REMARKS/ARGUMENTS

Claims 1-3, 5, 7-14, 16-21 and 23 remain in the application, all of which stand rejected. Claims 4, 6, 15, 22 and 24 have been canceled, without prejudice.

FIG. 3

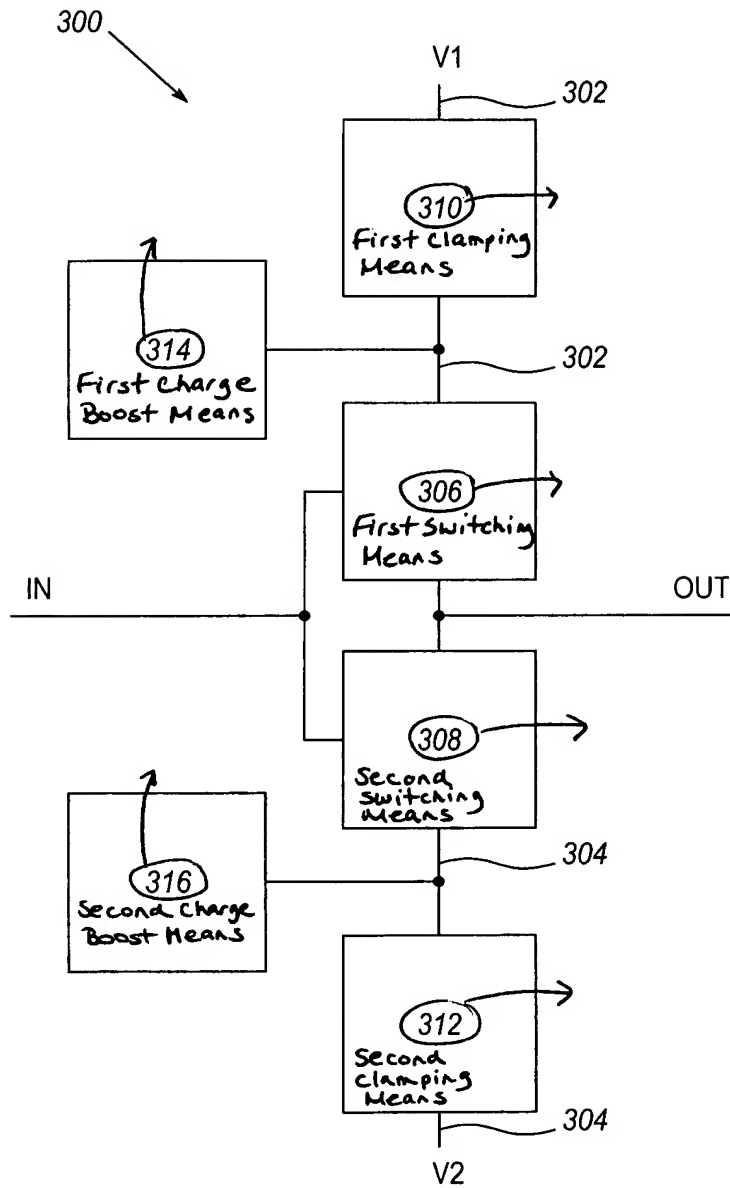
The Examiner objects to the drawings "because the black boxes in instant Fig. 3 need text labels." See, 1/13/2005 Office Action, sec. 2, p. 2.

Although applicants believe the reference numbers provided in FIG. 3 are sufficient to identify that which is disclosed (when combined with the corresponding description in paragraph [0017] of their specification), applicants submit herewith an amended FIG. 3 in which parts of the text description provided in their paragraph [0017] have been inserted. These amendments are not believed to add new matter.

The attached sheet of drawings includes changes to FIG. 3. This sheet, which only includes FIG. 3, replaces the original sheet including FIG. 3. In FIG. 3, text labels have been added to the boxes illustrated therein.
